TECHNICAL SERVICE BULLETIN

SUBJECT:		No: TSB-08-23-001	
CORRECTED SCAN TOOL EQUIPMENT PART NUMBERS - SERVICE MANUAL REVISION		DATE: January, 2008	
		MODEL: 2008 Outlander	
CIRCULATE TO:	☐ GENERAL MANAGER	☒ PARTS MANAGER	☒ TECHNICIAN
☒ SERVICE ADVISOR	☒ SERVICE MANAGER	☒ WARRANTY PROCESSOR	☐ SALES MANAGER

TSB Revision TSB-08-23-001

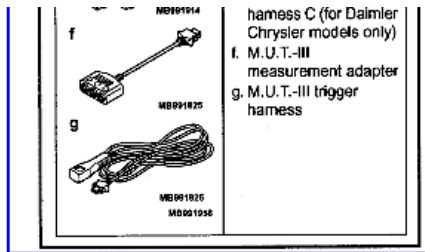
The information for equipment associated with the MUT-III Scan Tool is incorrect in the Service Manual. This TSB corrects the information.

2008 Outlander w/CVT only page 23A-126

SPECIAL TOOL			
Tool	Tool number and name	Supersession	Application
	MB991955 a: MB991824 b: MB991827 c: MB991910 d: MB991911 e: MB991825 f: MB991826 M.U.T.-III sub-assembly	MB991824-KIT NOTE: G: MB991826 M.U.T.-III trigger harness is not necessary when pushing V.C.I. ENTER key.	CVT check (M.U.T.-III diagnosis code display and service data display) CAUTION For vehicles with CAN communication, use the M.U.T.-III main harness A to send the simulated vehicle speed. If you connect the M.U.T.-III main harness B instead, the CAN communication does not function correctly.
	MB991824		
	MB991827		
	MB991910		
	MB991911		
	MB991825		
	MB991826		
	MB991955

Corrected Illustration	
	MB991955 a: MB991824 b: MB991827 c: MB991910 d: MB991911 e: MB991825 f: MB991826 g: MB991826 M.U.T.-III sub assembly
	a. Vehicle communication interface (V.C.I.)
	b. M.U.T.-III USB cable
	c. M.U.T.-III main harness A (Vehicles with CAN communication system)
	d. M.U.T.-III main harness B (Vehicles without CAN communication system)
	e. M.U.T.-III main
